City of Surrey  
**PLANNING & DEVELOPMENT REPORT**

File: 7910-0193-00

Planning Report Date: May 7, 2012

**PROPOSAL:**

**KEY SITE PLAN**

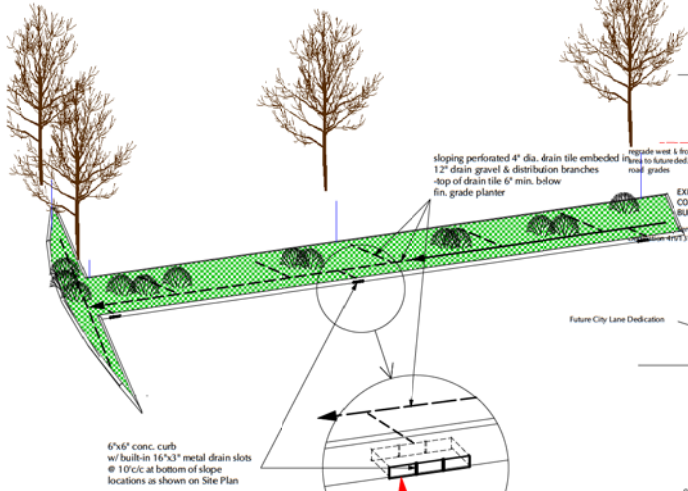
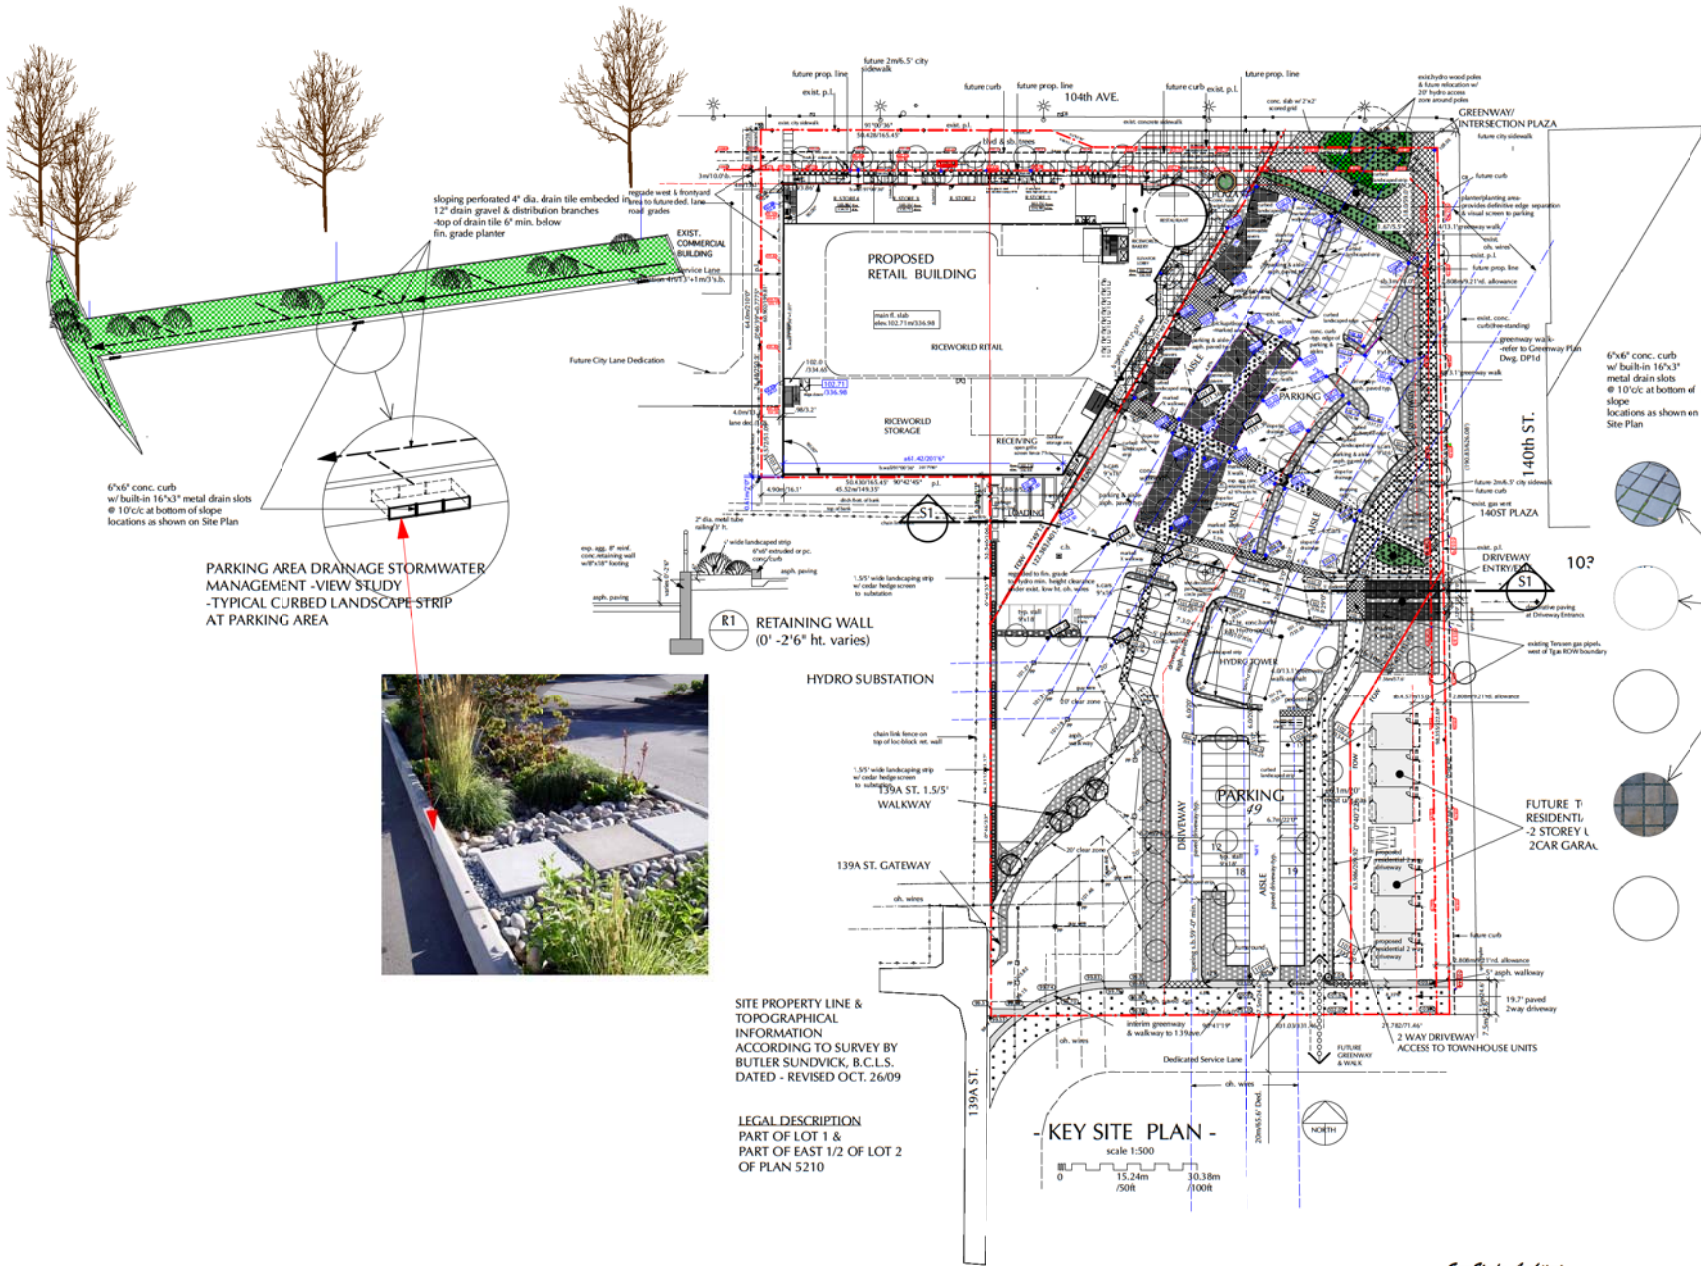
**Proposal: Proposed Relocation of Structure 22-05 of Line 2L022 to Support Commercial Development**  
**Location: SW Corner of 104th Avenue and 140 Street, Surrey, B.C.**  
**Drawing: Drawing No.: RDP1a - May10/11**

Based on the provided drawing, BC Hydro intends to install a new structure in place of structure 22-05 on 2L022 transmission line approximately 10 meters to the southwest. This is due to a future development near the intersection of 104th Ave. and 140th St. where the City of Surrey intends to expand the right turning lane of the east bound lane of 104th Ave.
